Nicholson Street, St Leonards – Build-to-Rent (SSD-88113706)

VIA Addendum - Response to DPHI RFI

Viewpoint 1: mid-level, south elevation

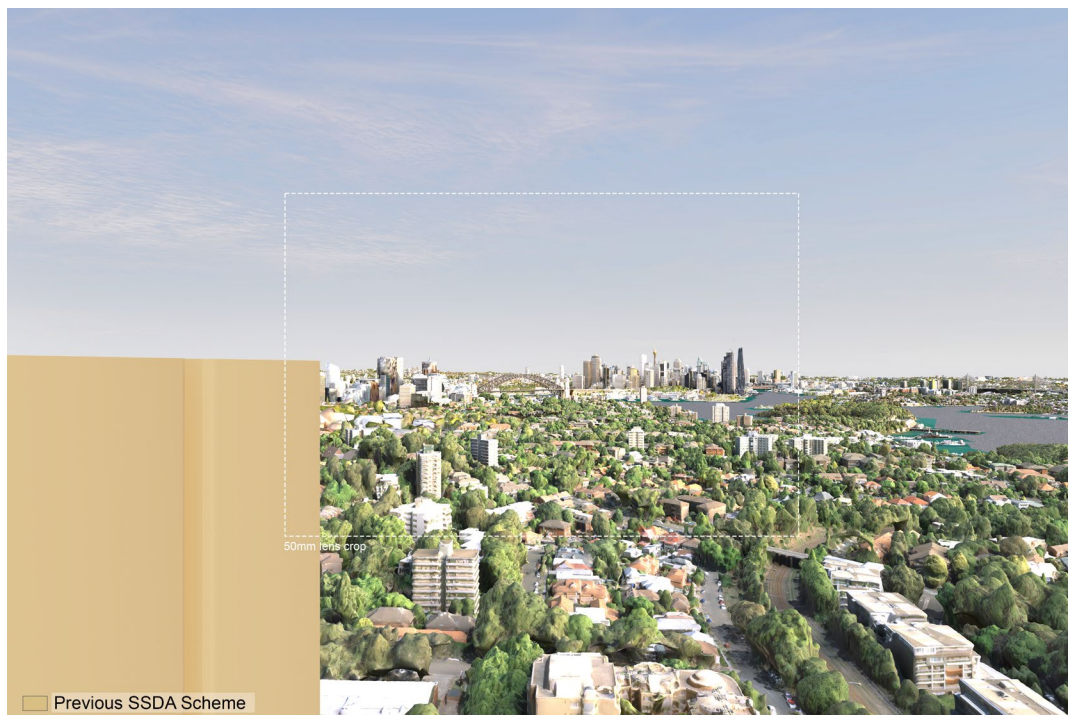
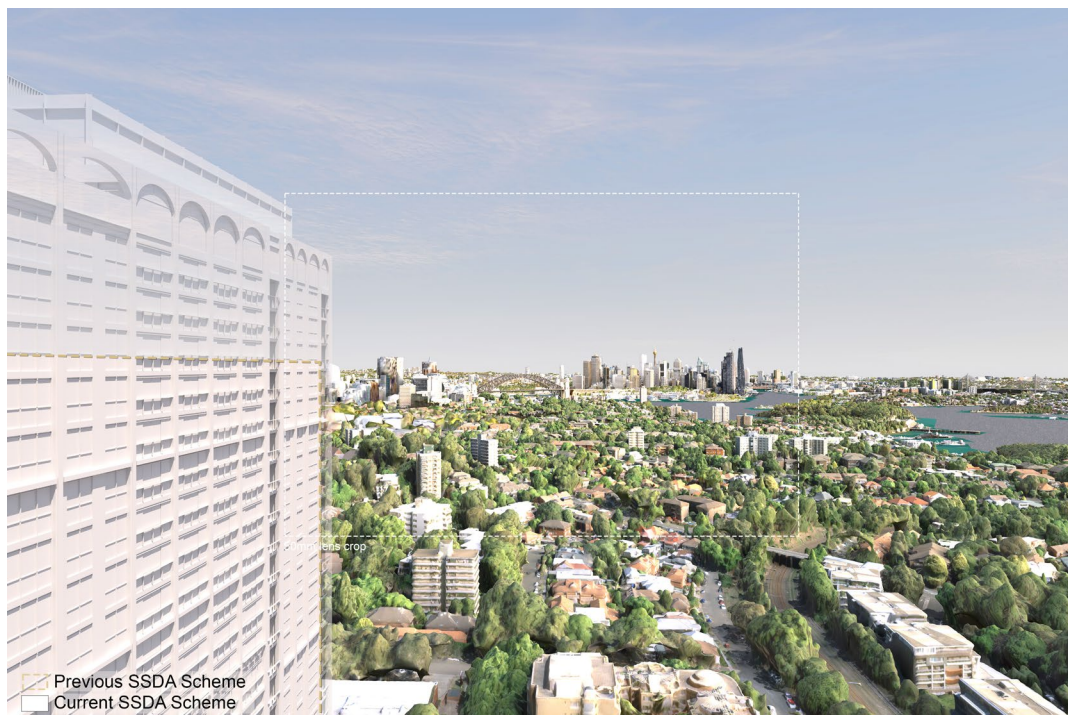
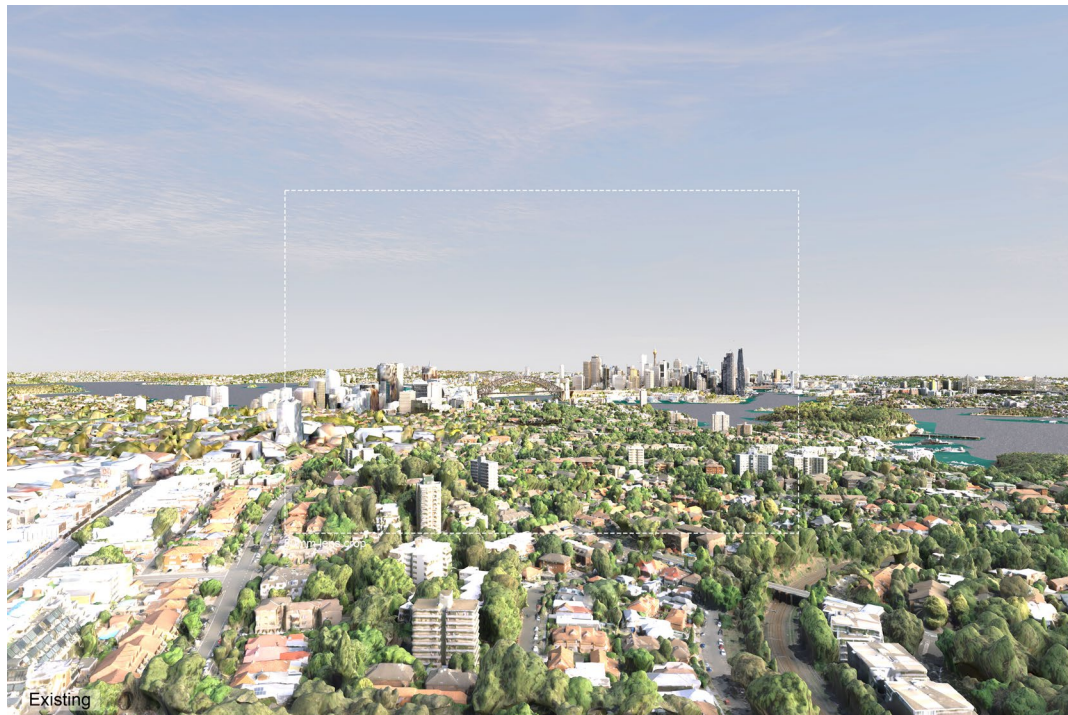
The VIA has not identified the potential view loss from the residential dwellings at 88 Christie Street. Please provide an updated VIA that addresses this matter, particularly the potential iconic view loss from this site.

Tenacity step 3: Assess the extent of impact

- In terms of bulk, when seen from this view the proposal generally aligns with the building envelope established by the approved SSDA scheme.
- View impact arises due to increased tower height, and results in blocking views to the sky, with views to iconic elements retained.
- Given the site is located to the south-east, it is only visible obliquely from this location, enabling views beyond the proposal to the south (inclusive of iconic elements) to be retained.
- This retains the existing extent of views to Sydney Harbour, the Sydney Harbour Bridge, the Sydney CBD, and the Anzac Bridge.
- While the view change is moderate, overall the qualitative assessed extent of the additional view impact is minor.

Built form massing reduction diagram

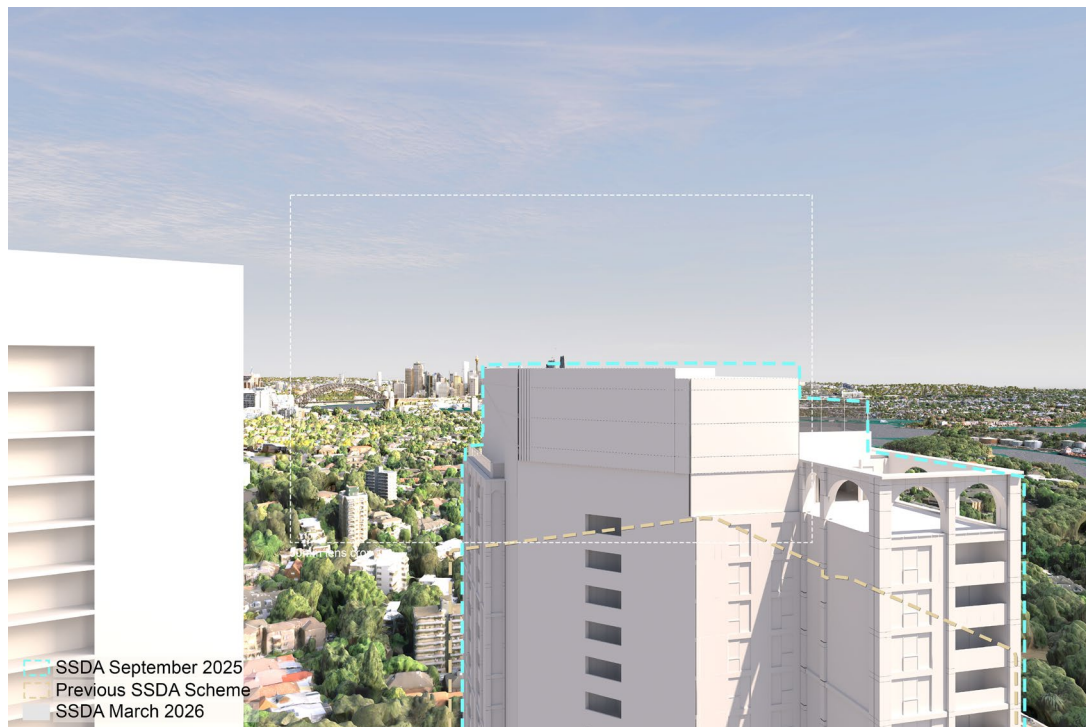
'The Department requests a revised scheme and Planning Proposal that acknowledges and appropriately manages iconic and landmark views from existing and approved residential developments in the locality. The revised plans should be supported by an updated Visual Impact Assessment (VIA) and demonstrate how the proposed massing responds to view corridors'.

An amendment to the roofline of the proposed building form was undertaken in March 2026. Demonstrated in the diagram below this roofline amendment has resulted in a staggered reduction in building form, lowering the overall building height between 400mm – 1,250mm.

The Landmark, viewpoint 8: proposed view showing amended roofline and previous September 2025 scheme

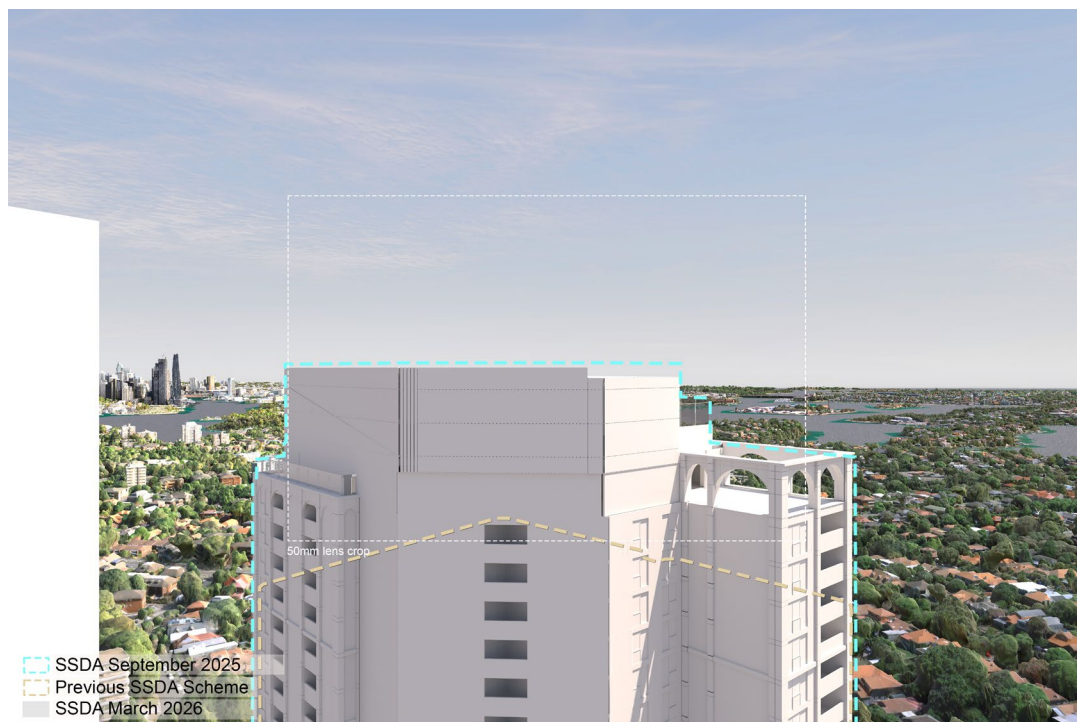
The Department considers it important to balance the provision of housing with the amenity of the locality, while being mindful of impacts on surrounding development. The proposed height increase under the planning proposal and visual impact will result in severe view loss of iconic landmarks from existing and approved residential developments (Telstra Exchange BTR, The Landmark, and St Leonards Square.

With regard to the proposed amended roofline, the staggered reduction in building form results in improvements to views from the upper levels of St Leonards Square, The Landmark and Telstra Exchange, with increased portions of building silhouettes within the Sydney CBD and sky visible.
